Electric Vehicle Safety

Session # 19

Proposal of amendments to the rules of the UN Regulation No. 100

Suggestions of expert from the Russian Federation

Figure 1

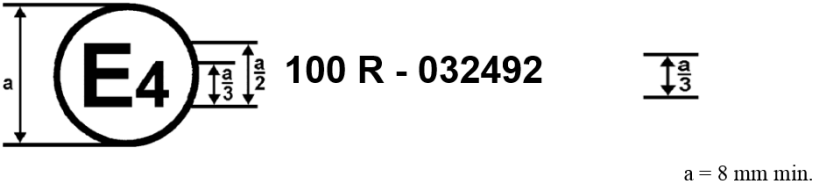
Annex 2, amend to read:

The approval mark in Figure 1 affixed to a vehicle shows that the road vehicle type concerned has been approved in the Netherlands (E 4), pursuant to Regulation No. 100, and under the approval number 032492. The first two digits of the approval number indicate that the approval was granted in accordance with the requirements of Regulation No. 100 as amended by 03 series of amendments.

Figure 2

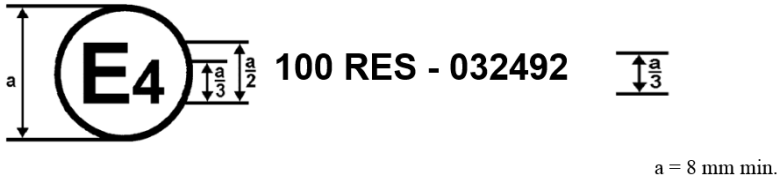
The approval mark in Figure 2 affixed to a REESS shows that the REESS type ("ES") concerned has been approved in the Netherlands (E 4), pursuant to Regulation No. 100, and under the approval number 032492. The first two digits of the approval number indicate that the approval was granted in accordance with the requirements of Regulation No. 100 as amended by 03 series of amendments.

Model B (see paragraph 4.5 of this Regulation)

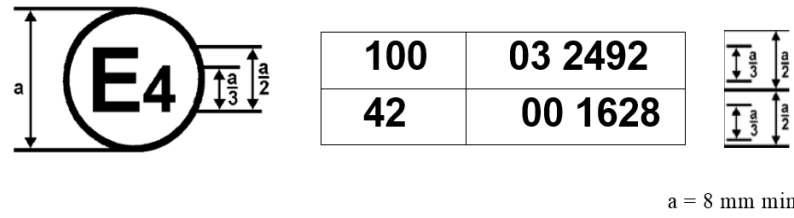
The above approval mark affixed to a vehicle shows that the road vehicle concerned has been approved in the Netherlands (E4) pursuant to Regulations Nos. 100 and 42*. The first two digits of the approval number indicate that, at the dates when the respective approvals were granted, Regulation No. 100 was amended by the 03 series of amendments and Regulation No. 42 was still in its original form.
